ITEM 6.2: **Conditional Use Permit and Design Review Permit – 1590 Vineyard Road – INFILL PCL 211 – Quick Quack Car Wash – File #PL22-0272**

REQUEST

The applicant requests approval of a Conditional Use Permit and a Design Review Permit to allow a ±4,300 square foot automatic car wash facility, with 23 vacuum spaces on a ±2-acre parcel with associated parking, lighting, and landscaping improvements.

Figure 2: Proposed Site Plan

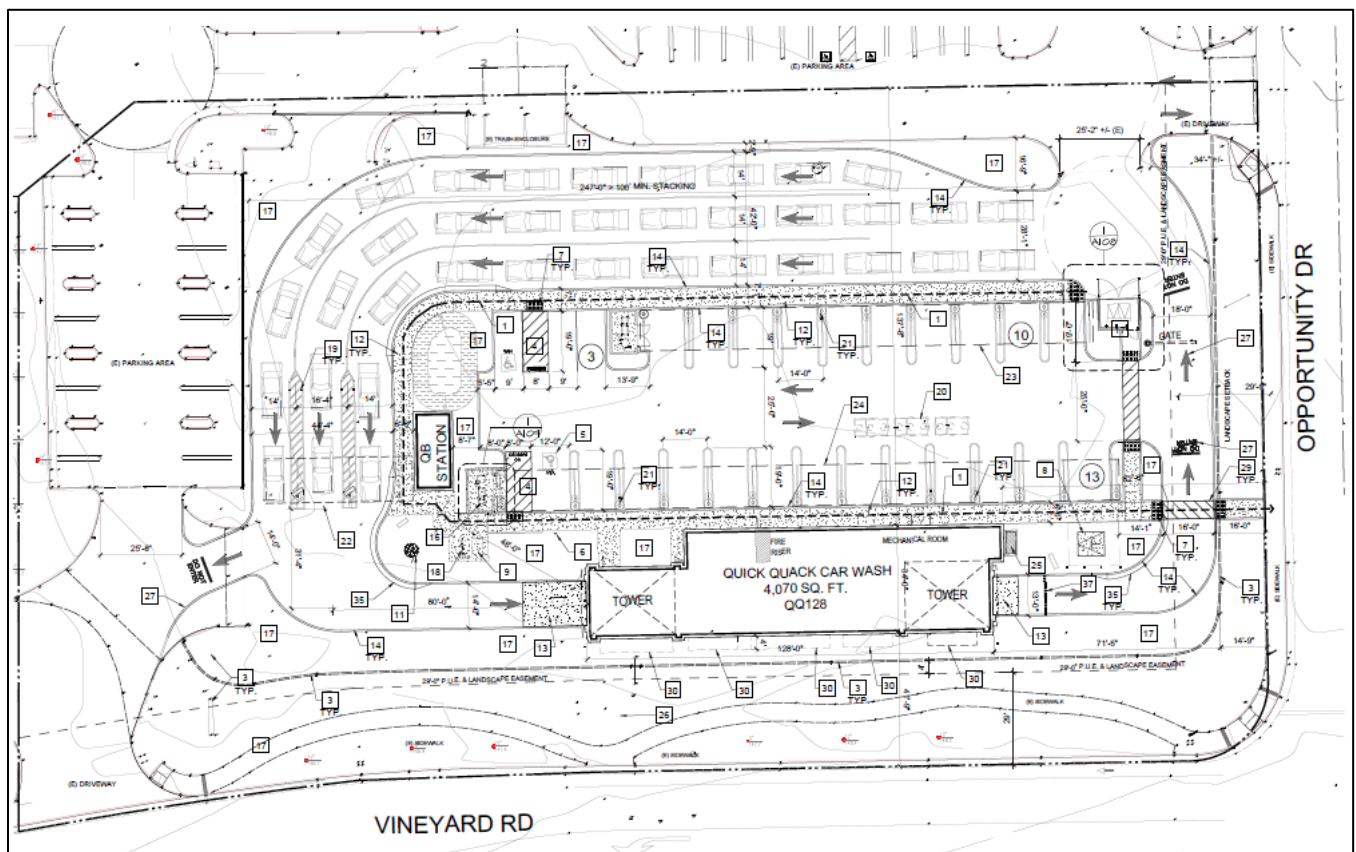
Ingress and egress for the project site will be provided via two existing driveways. One entrance will be provided from Vineyard Road and the second will be provided via Opportunity Drive. The project site will also be accessible through the existing Vineyard Pointe commercial center driveway along Foothills Boulevard.

The drive through lane will begin at the northeast corner of the site, along Opportunity Drive, and split into three stacking lanes, providing adequate space for waiting vehicles. Overflow traffic will not impact public right-of-way. The site is designed with an emergency exit at the southwest corner of the site, adjacent to the Chevron station. In the event a customer needs to exit the site, they would be allowed to do so by exiting through this "Exit only" driveway. Once customers exit the car wash tunnel, they will have the option to enter the parking area with the vacuum spaces or exit the site. Customers will be allowed to exit the site to Opportunity Drive or through the commercial center. The site plan shows that an accessible path of travel will connect to the existing pedestrian facilities along the Opportunity Drive and Vineyard Road frontage. Although the use is auto-oriented, a bicycle rack and storage area are provided on-site.

The CDG requires that all car washes and automatic teller machines provide a minimum of 100-feet of stacking distance that does not conflict with the on-site parking and circulation system. As proposed, the inside lane of the stacking area has approximately 240-feet of stacking distance measured from the project entrance to the car wash building entrance. The total stacking distance for the three lanes is approximately 750-feet. The site is designed to provide ample room for vehicles to stack and to be contained on-site without interrupting the on-street flow of traffic.

Figure 3: Project Noise Contours

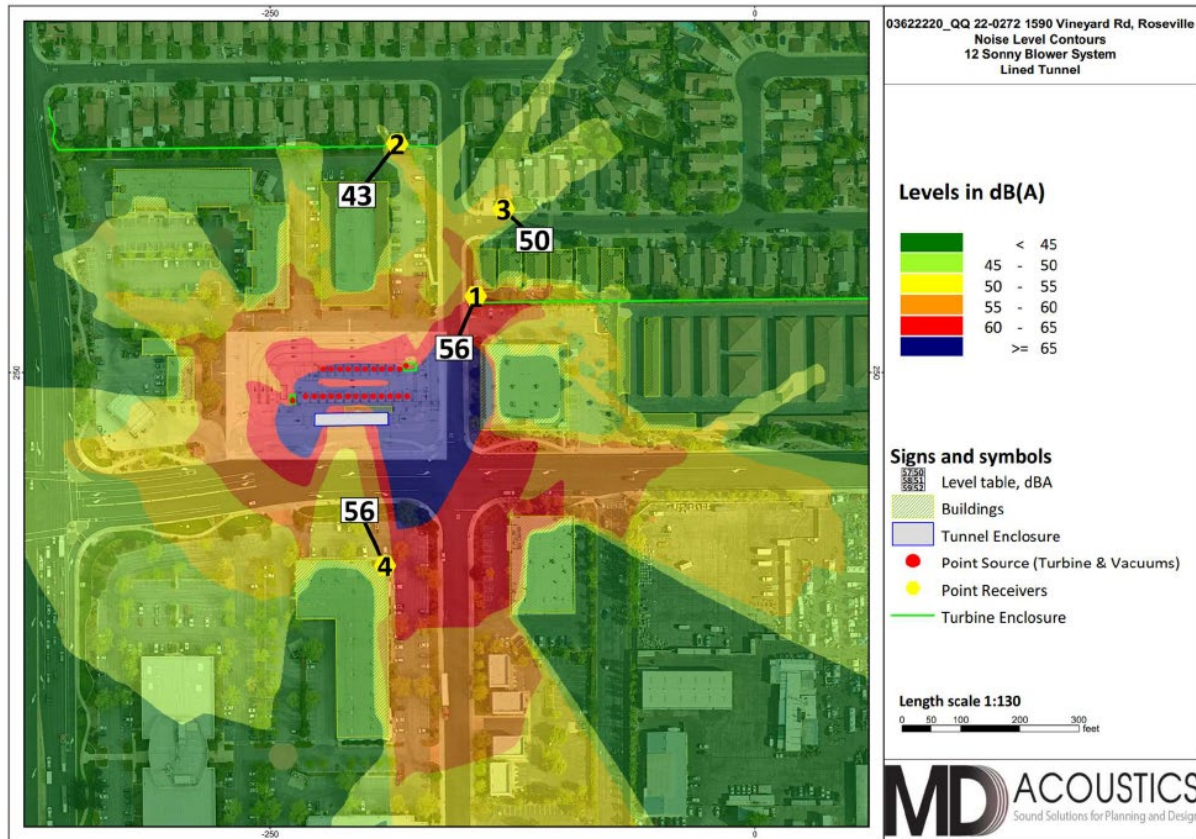
The model found that the project noise levels will increase the ambient noise at the existing sensitive receptors by a maximum of 2 dBA. Figure 3 below from the study shows the project noise contours. Based on the total combined noise levels, the project is still within the City's maximum noise levels.

As part of the project design, the carwash tunnel and vacuum stations are oriented to place the loudest equipment as far from the residents as possible within the constraints of the site. Staff worked with the applicant early on in the process to see if the building orientation of the car wash tunnel could be moved and faced away from the existing sensitive receptors, but based on the on-site queuing that is anticipated to occur from the use, the applicant elected to keep the site layout as originally proposed to accommodate for all queuing to occur on-site. The exit for the tunnel, where the air dryers are located, are on the east side of the tunnel, oriented towards the existing commercial building. The vacuum stalls are to the north of the building, behind the building and not visible from Vineyard Road. In addition, the building and air dryers will be approximately 150 feet from the nearest single-family dwelling unit, with landscaping, a two-lane roadway and a six-foot masonry wall. As the proposed project is not anticipated to exceed noise standards at the property line during daytime hours (established by the Municipal Code Section 9.24.100 as 7:00 AM to 10:00 PM), no mitigation measures are recommended; however, the project includes a CUP, which will include a condition of approval to limit the hours of operation to 7:30 AM -8:30 PM Monday through Friday and 8:00 AM to 8:30 PM on weekends and holidays (CUP Condition #2), this condition of approval is consistent with other previously approved automatic car wash facilities in the City.
